Subject: Comments regarding NUREG-1437, Supplement 14  
R. E. Ginna Nuclear Power Plant  
Docket No. 50-244

## **ATTACHMENT A: RG&E COMMENTS ON NUREG-1437, SUPPLEMENT 14**

# ATTACHMENT B

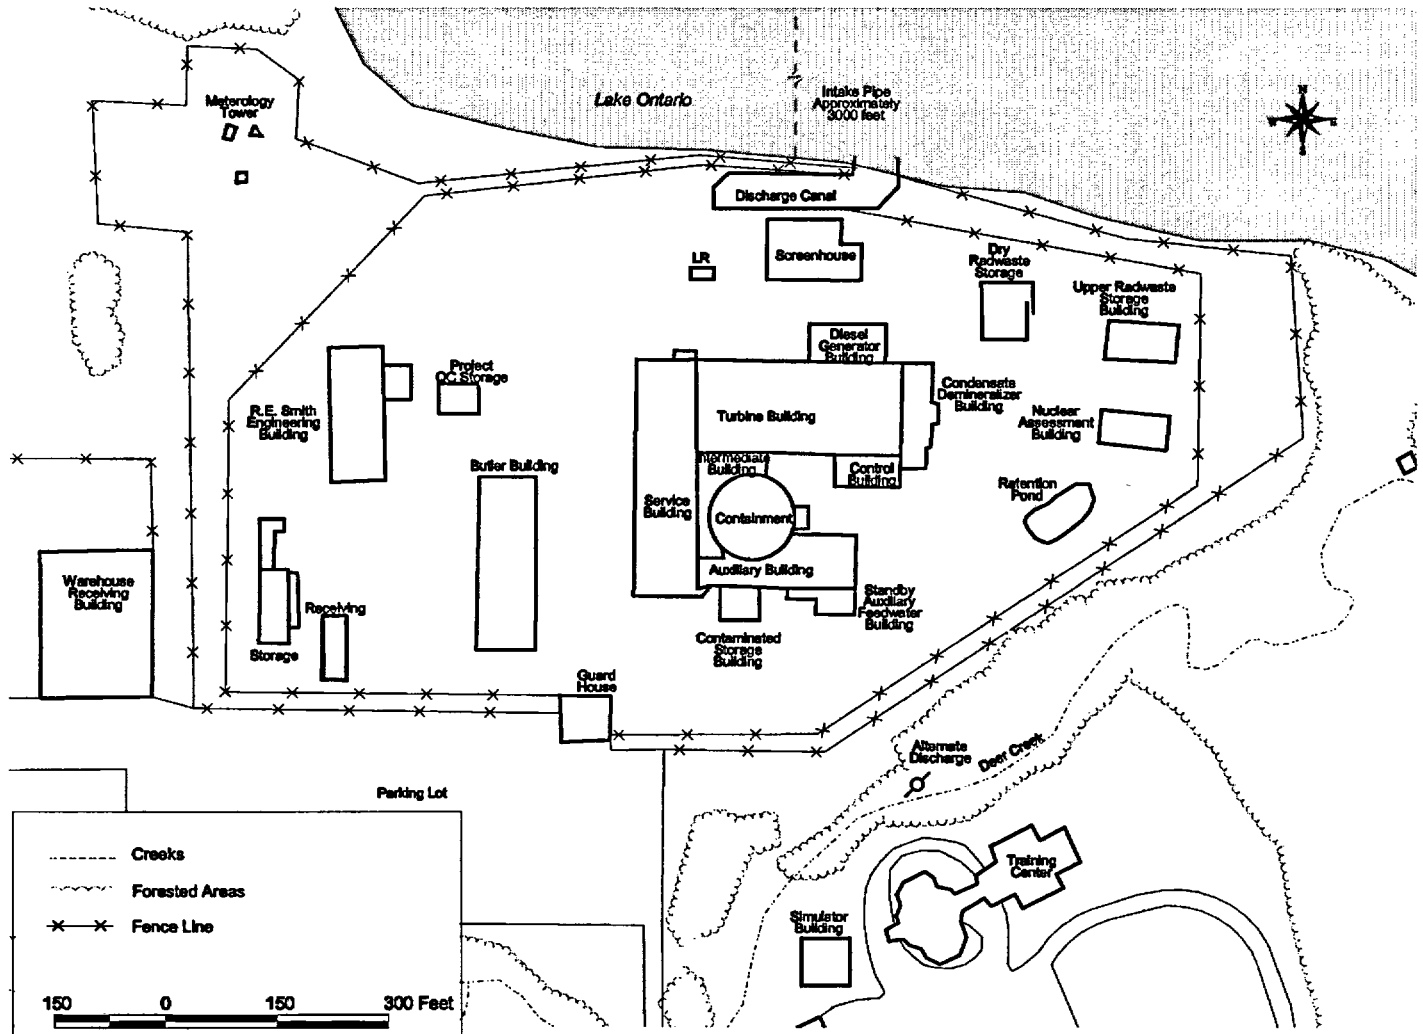
- Comment 1:** There is a typographical error on page 2-1, line 29. 0.9 km should be 2.4 km.
- Comment 2:** Minor changes should be made to Figure 2-3, as provided in Attachment B.

# ATTACHMENT C

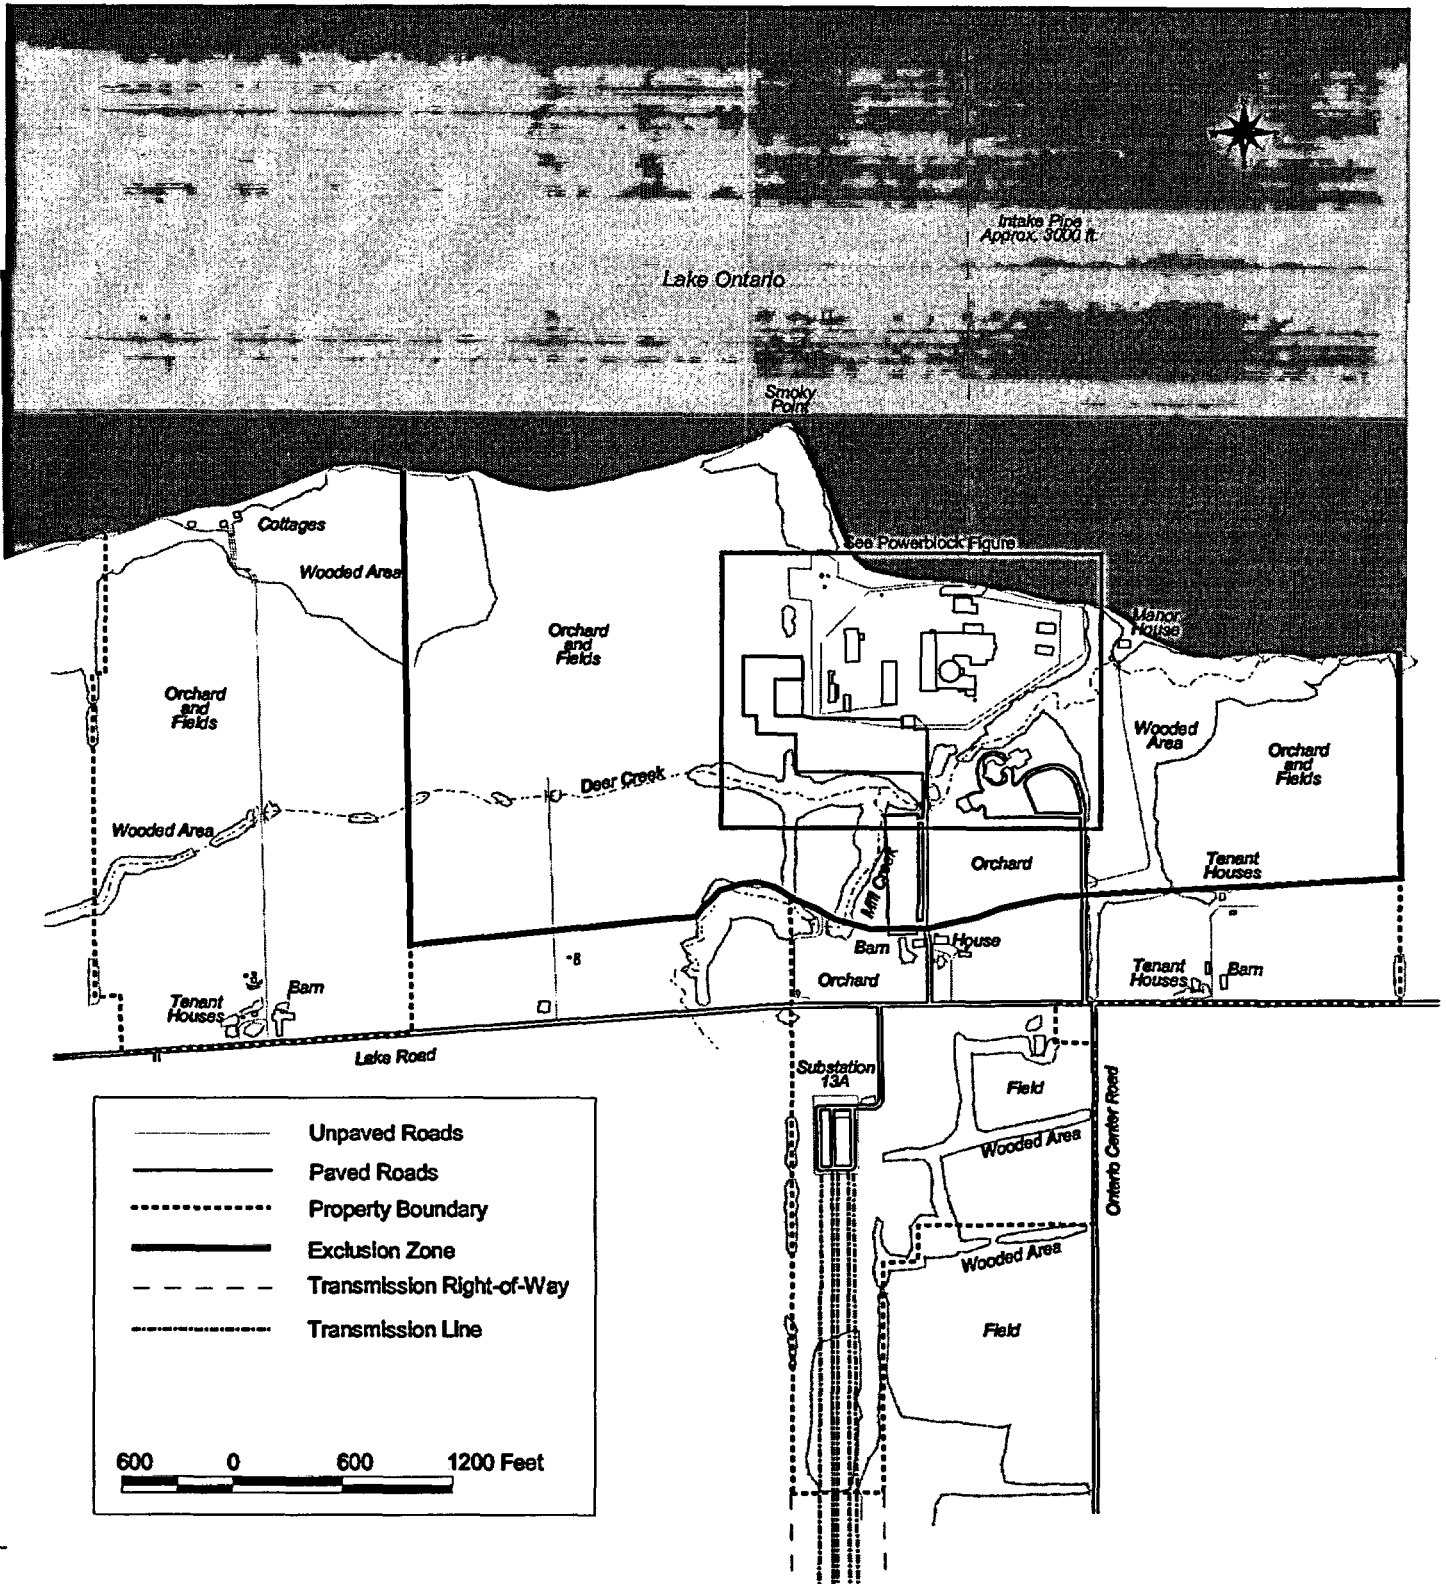
- Comment 3:** Minor changes should be made to Figure 2-4, as provided in Attachment C.
- Comment 4:** In Section 2.2, page 2-17, line 25-27, reference is made to a land transaction. This has not occurred; therefore, this sentence should be deleted.
